ELECTRICAL AND MECHANICAL
ENGINEERING INSTRUCTIONS

TRUCK UTILITY LIGHTWEIGHT MC2
LANDROVER SERIES III ALL TYPES
REWIRING OF HEADLIGHT CIRCUIT

MODIFICATION INSTRUCTION

FIG 1 - CIRCUIT DIAGRAM OF LANDROVER SERIES 3

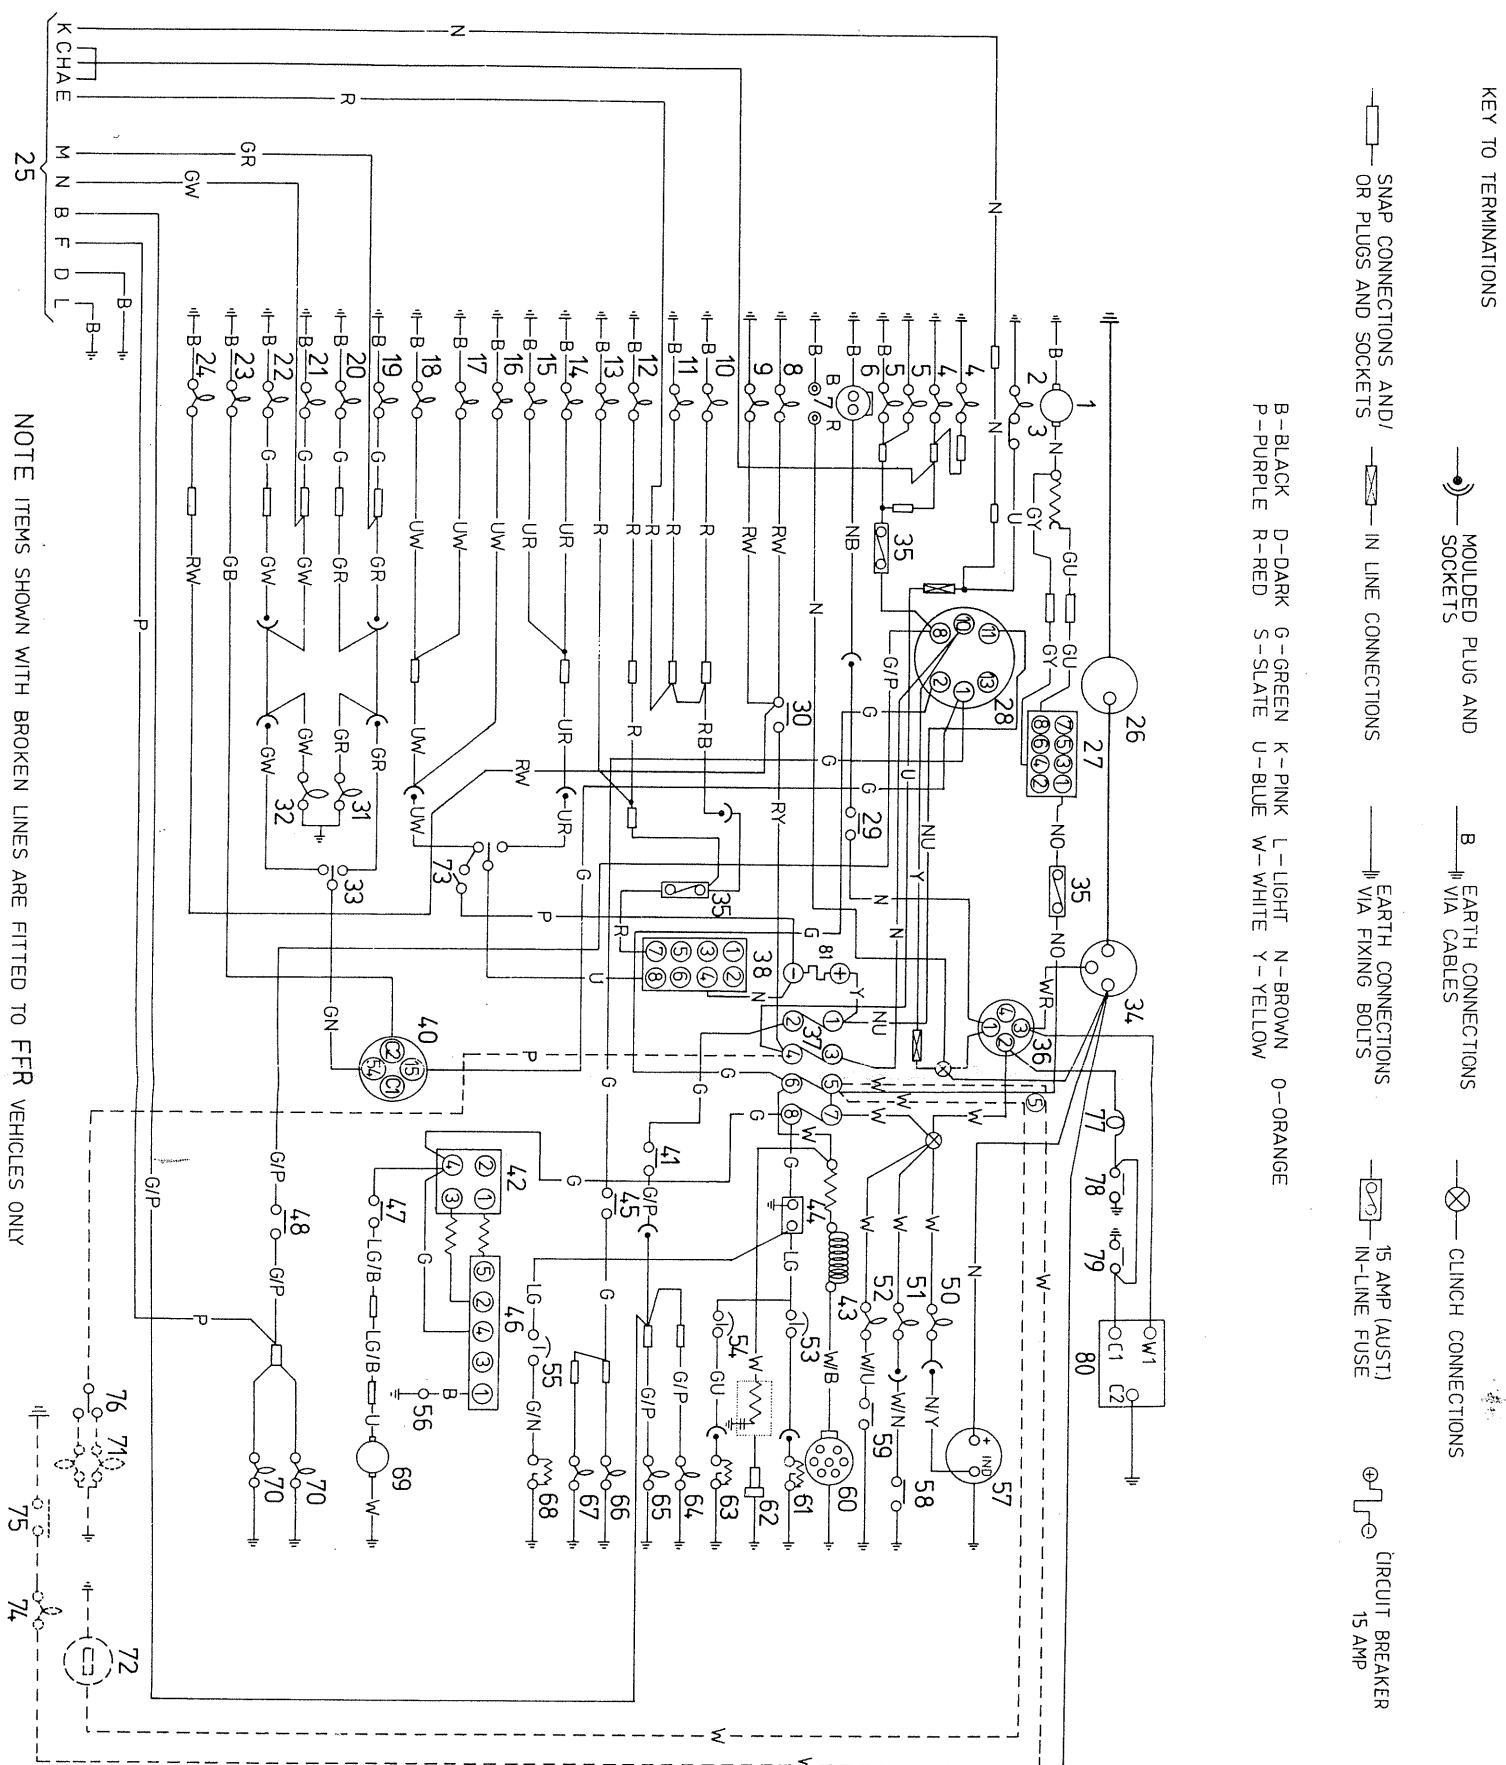
1. Instances have occurred where the plastic surrounding pins 3 and 4 in the fuse box have melted.
2. This modification details the fitting of a circuit breaker to the headlight circuit to prevent the fuse box melting while the headlights are on for an extended period. This instruction is to be read in conjunction with EMEI VEH G 303-1 and G 307-13.

- c. Remove the power feed wire (brown wire) from terminal 3 of the fuse box and re-route to terminal 10 of the blackout switch, (terminal 2 of santon type switch). Use items 1 and 2 of Table 1 to lengthen the power feed wire.

- d. Remove the map light wire (blue wire) and auxiliary power feed wire (brown wire) from terminal 10 of the blackout light switch, (terminal 2 of santon type switch) taking care to remove the correct brown wire.

- e. Identify the brown wire connected between terminal 4 of the fuse box and terminal 10 of the blackout switch (terminal 2 of the santon type switch). Disconnect this wire from terminal 4 and reconnect to terminal 3 of the fuse box.

- f. Using items 4, 5 and 6 of Table 1, join the map light wire and the auxiliary power feed wire and re-route to the fuse box terminal 4.
 - g. Mount the circuit breaker (item 7 of Table 1) to the flasher can mounting screw.

- h. Using items 2, 3, 4 and 6 of Table 1, join the positive terminal of the circuit breaker (item 7) to the fuse box terminal 1.
 - i. Disconnect the high beam flash feed wire (purple wire) and the headlight feed wire (brown wire) from the fuse box terminal 1 and re-connect both wires to the negative terminal of the circuit breaker (item 7).

- j. Check that the modified wiring corresponds to that shown in Fig 1 and reconnect the battery.
 - k. Test the operation of headlights in both normal and blackout modes.
